AGENDA
HANOVER CITY COUNCIL
APRIL 3, 2018

Date:	March 28, 2018
To:	Honorable Mayor and Council
From:	Cindy Nash, City Planner
RE:	Hanover Dental – Site Plan

Re: ***Hanover Dental Plan Review***
WSB Project No. 011692

C-102

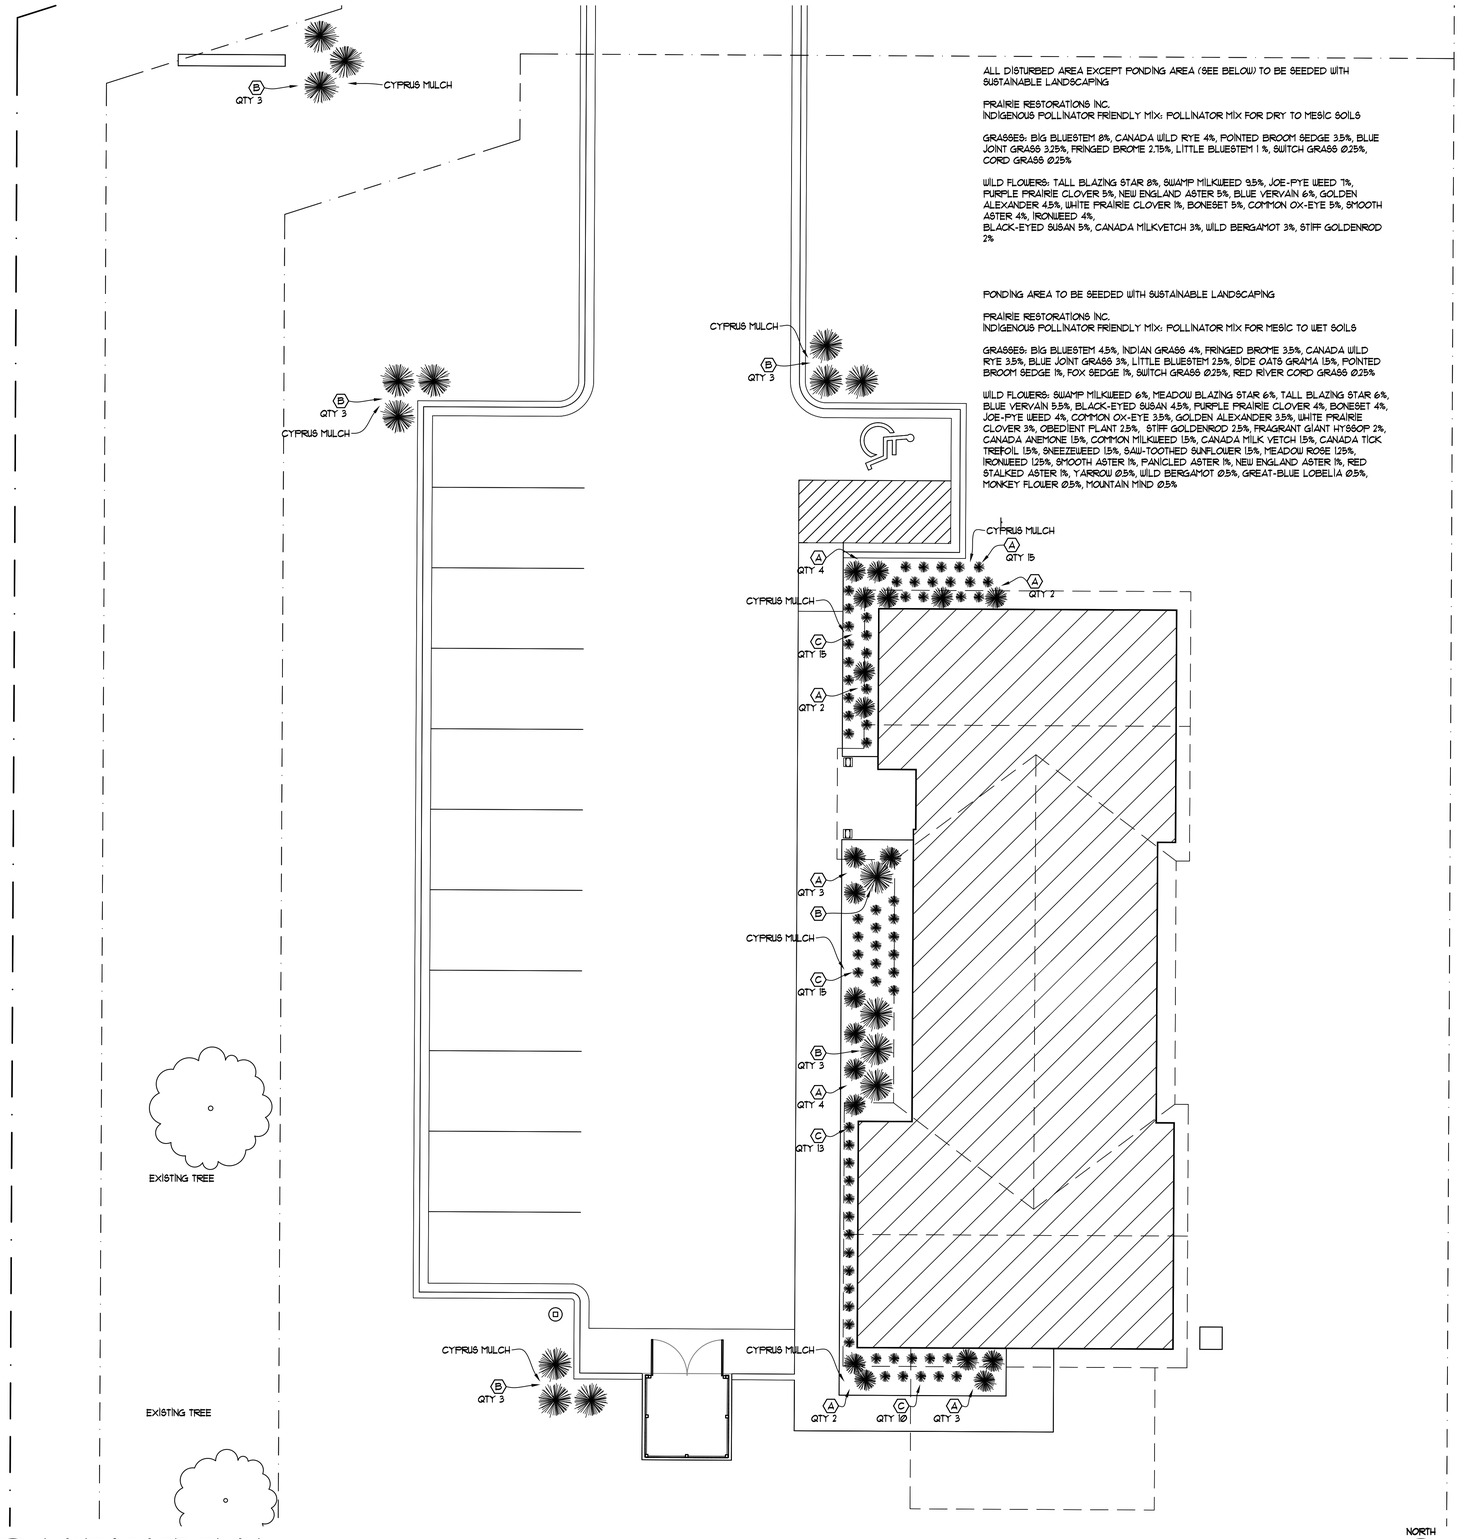
15. Remove the word 'manhole' from the label for the existing invert elevation of the sanitary sewer service stub at the main on sheet C-102 which seems to imply a structure exists at the junction.
